General Meeting

11 February 2020

ITEM 2.2 DA/39443/2019/V2D - MATERIAL CHANGE OF USE - DEVELOPMENT PERMIT FOR DUAL OCCUPANCY LOCATED AT 28 FERNLEA AVENUE, SCARBOROUGH - DIVISION 5 - A19563599 (Cont.)

#5 Properly made submissions

Figure 5 Scarborough Avenue Perspective Source: Except from plans by Cyber Drafting & Design

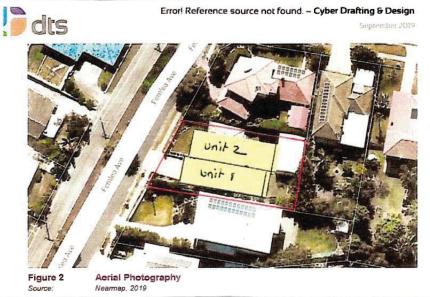
- Two (2) x three-bedroom dwelling units;
- 2 storey built form;
 O
- 45% site coverage; 100 much
- Access via two (2) new 3m wide crossovers servicing each dwelling unit;
- Generous private open space areas;
- Ample landscaping and deep planting areas.

Too Developed
